City of Plymouth Planning Commission Regular Meeting Agenda

Wednesday, May 12, 2021 - 7:00 p.m.

MEMORANDUM

Site Plan Review For Plymouth, Michigan

Shown with a 3:12 pitch (roof would not be visible from the road) **Front Elevation Right Elevation** Lot #2

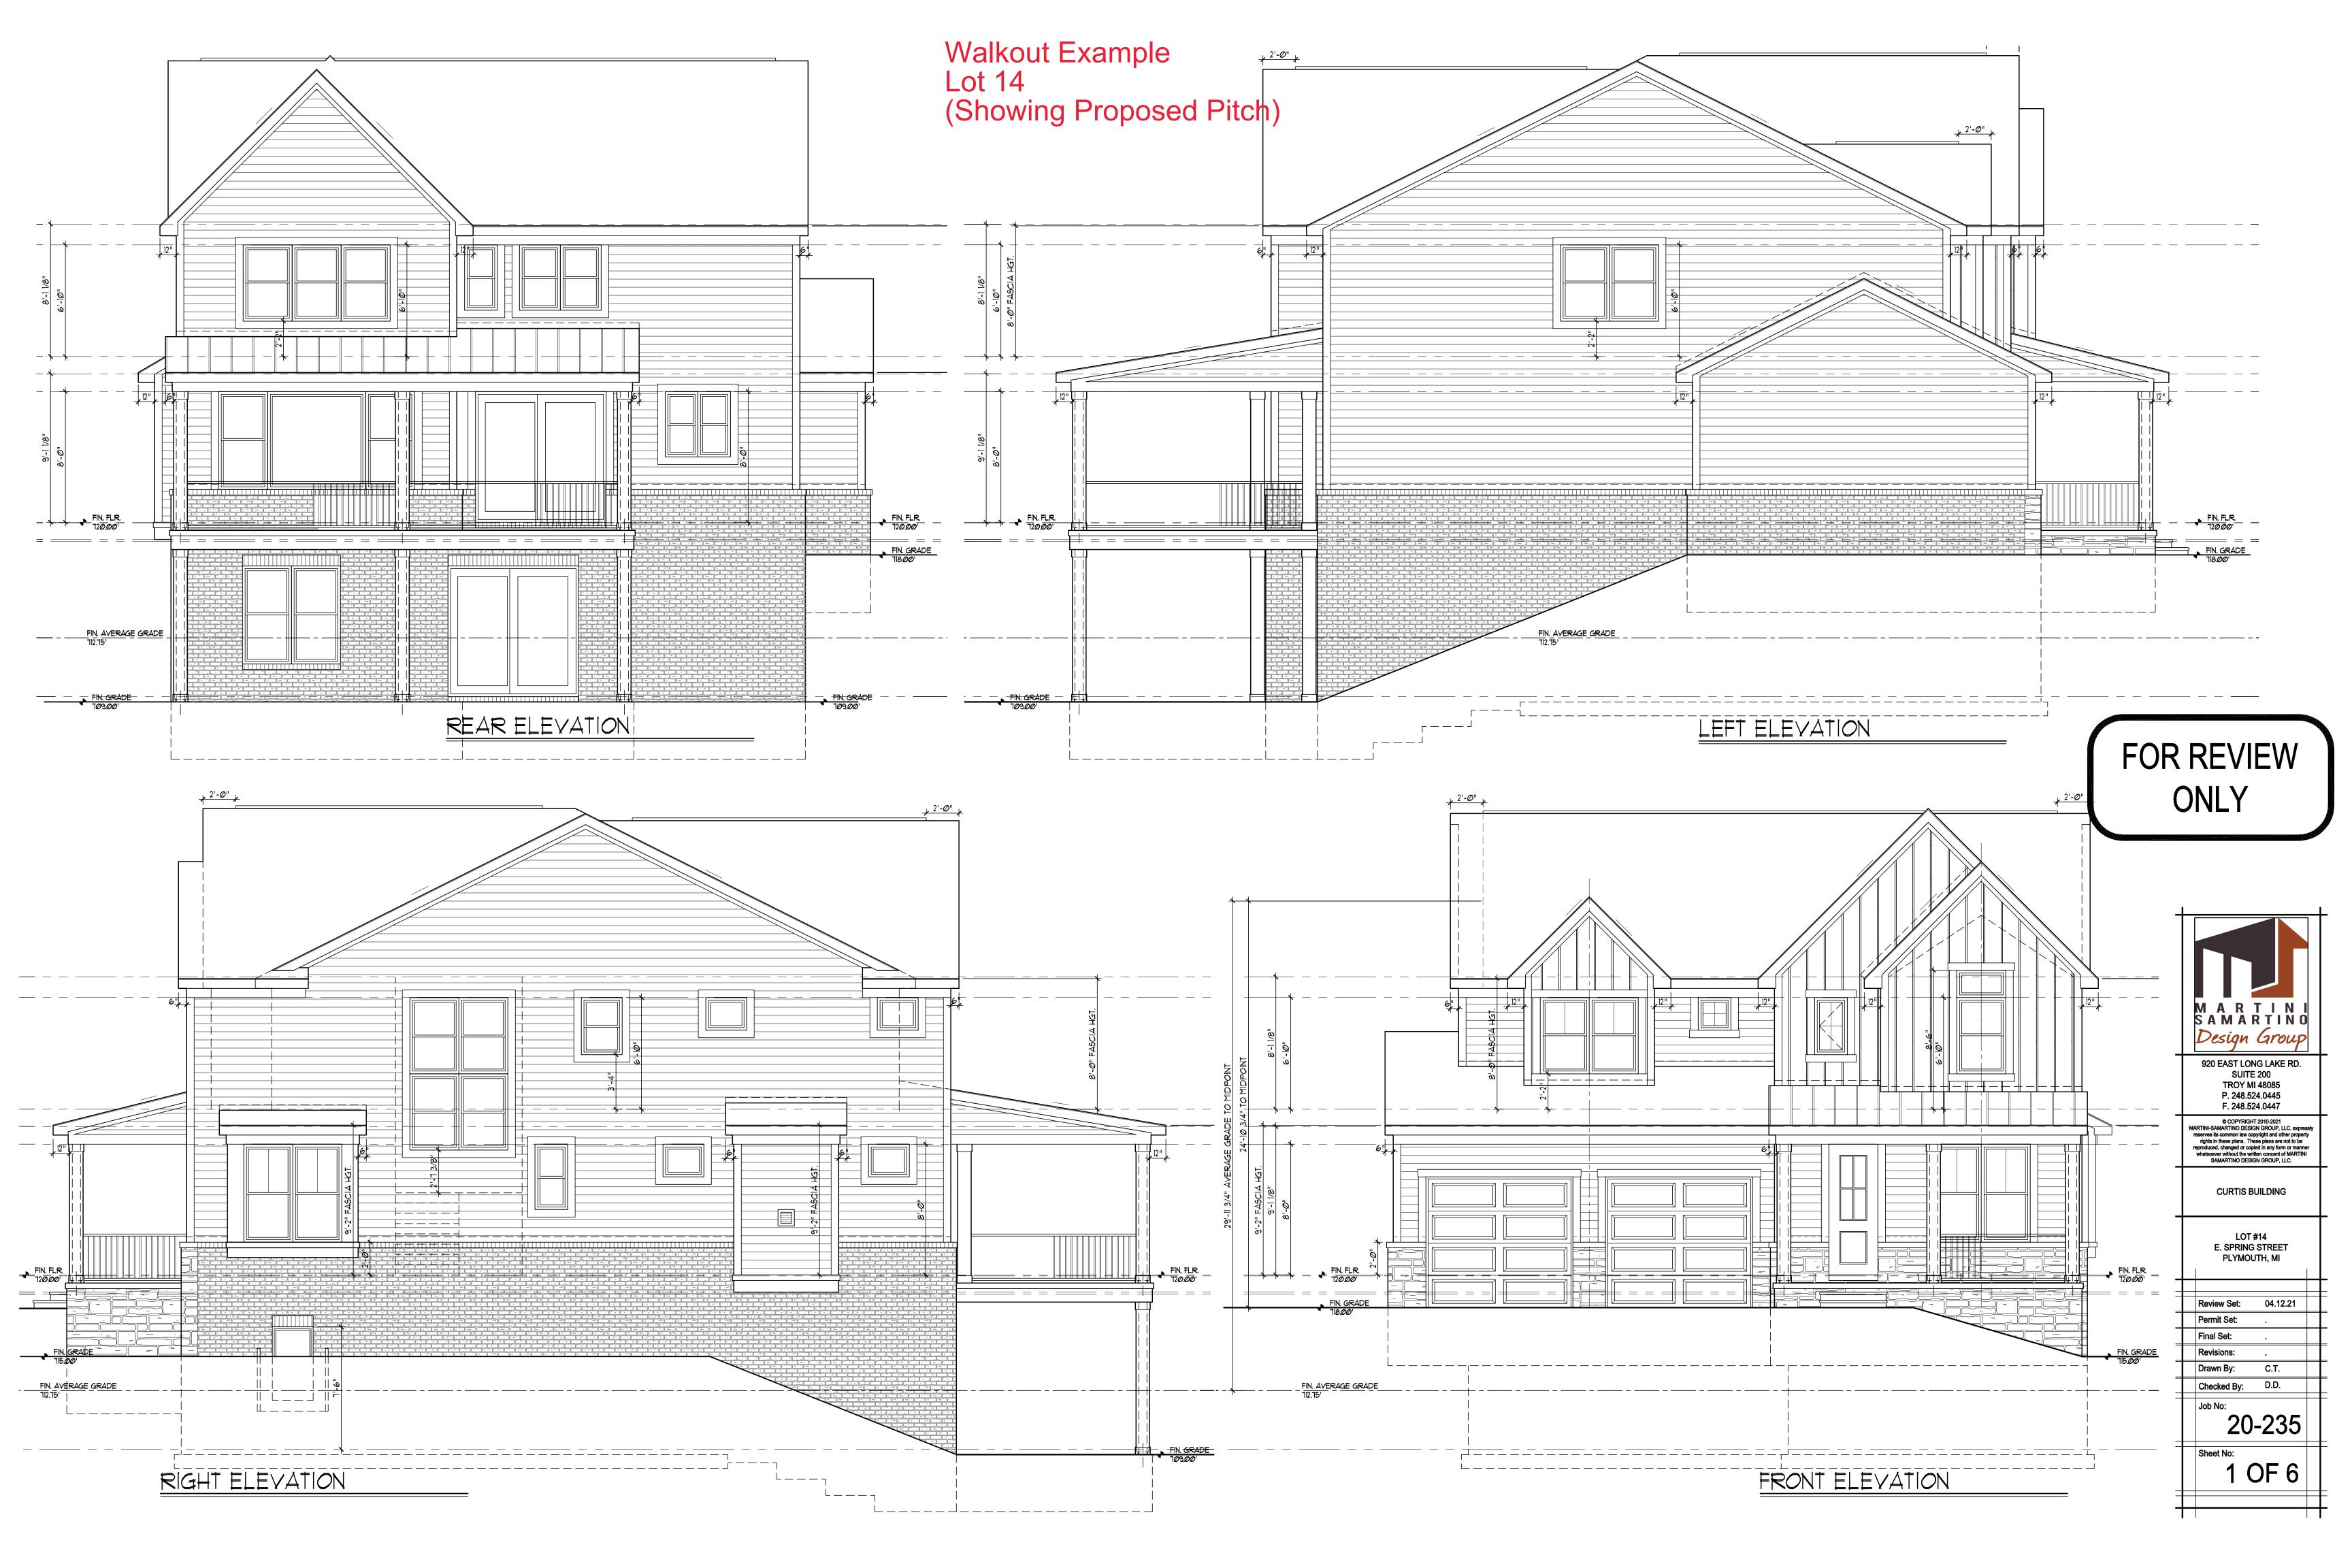
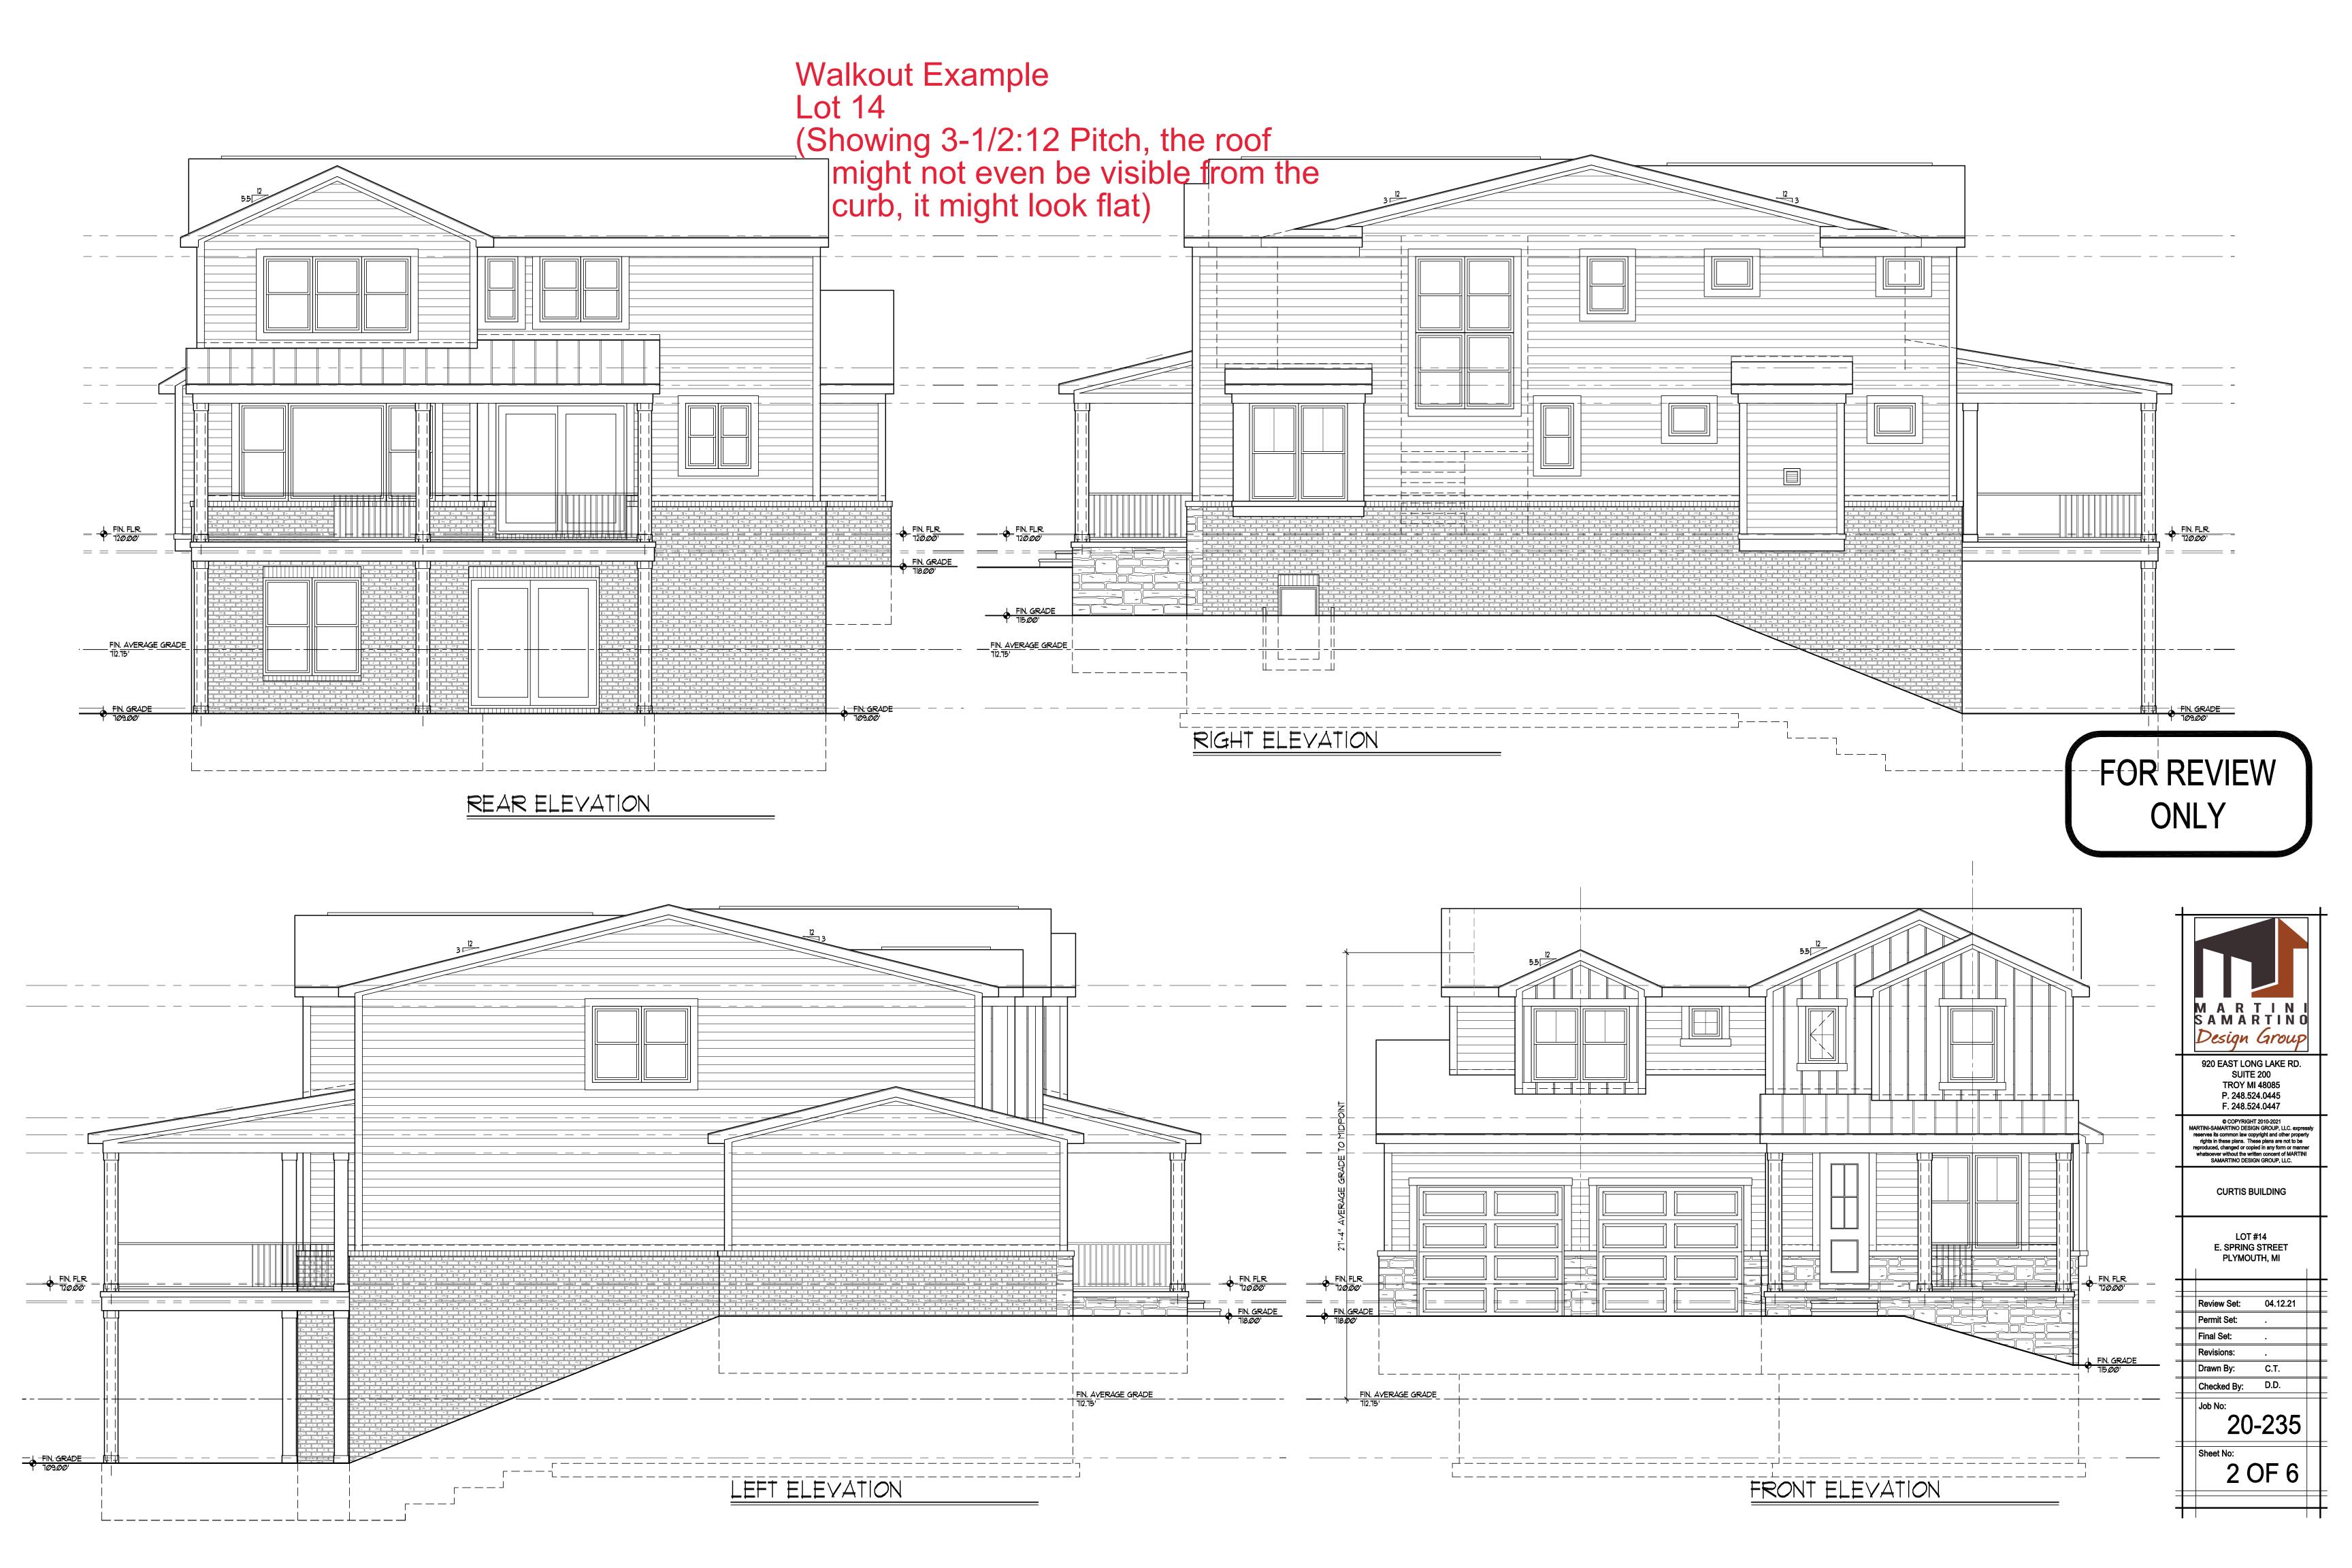
<u>CWA Comments</u>: The narrative states that the calculations for building height assume the ceiling heights proposed by the Planning Commission. The building elevations for Lot 14 show 9.5-foot tall basement ceiling heights. We would ask the applicant's Engineer to explain if tall basement ceilings affect the ultimate height of the house.
